SERVICE BULLETIN

#0004

SUBJECT: Placement of the ELT antenna

MODELS AFFECTED: All Sling LSA, Sling 2, Sling Taildragger & Sling 4 aircraft where an ELT is installed

EXPLODED VIEW

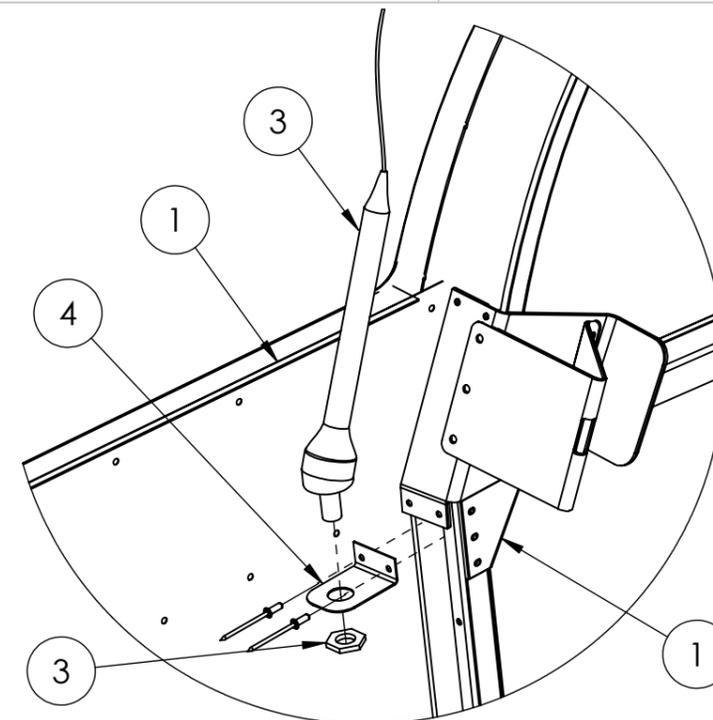
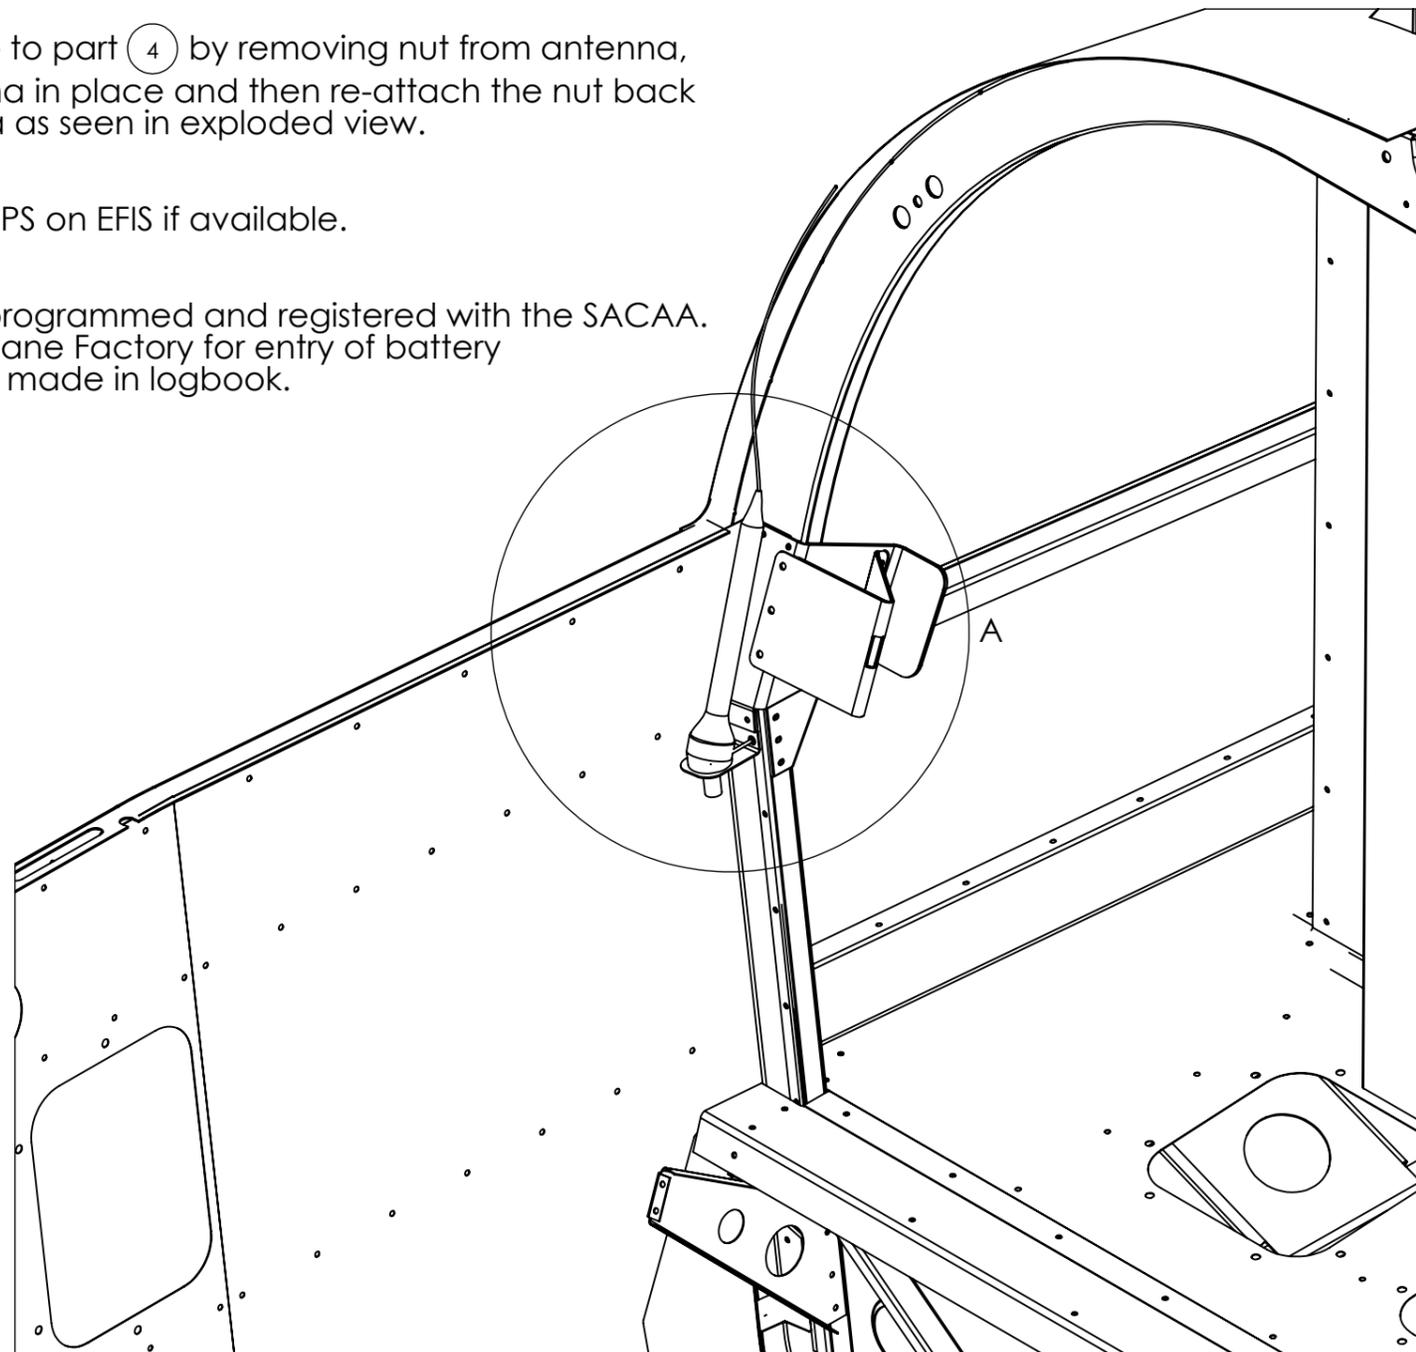
Whilst holding part (4) below the bottom flange of the right hand seat backrest stop (as seen in assembled view) drill first 3.3mm hole and cleco, then drill second hole.

Rivet part (4) with two 3.2 x 8mm Aluminium Domed Rivets into the holes drilled in step 1.

Connect part (3) to part (4) by removing nut from antenna, place the antenna in place and then re-attach the nut back onto the antenna as seen in exploded view.

**ASSEMBLED VIEW
(DETAIL A)**

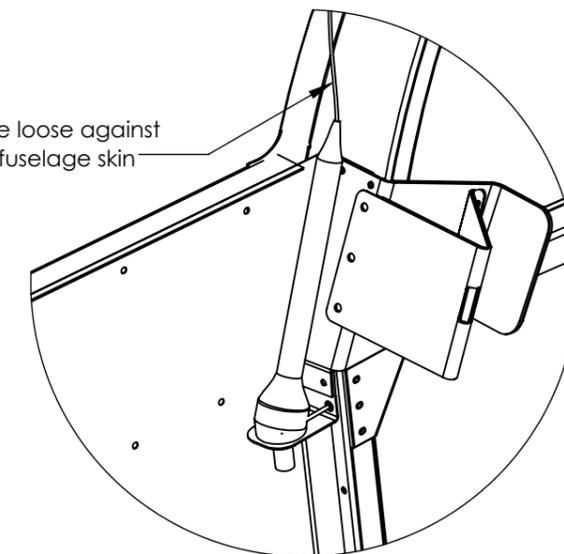
The antenna will lie loose against the inside of the fuselage skin
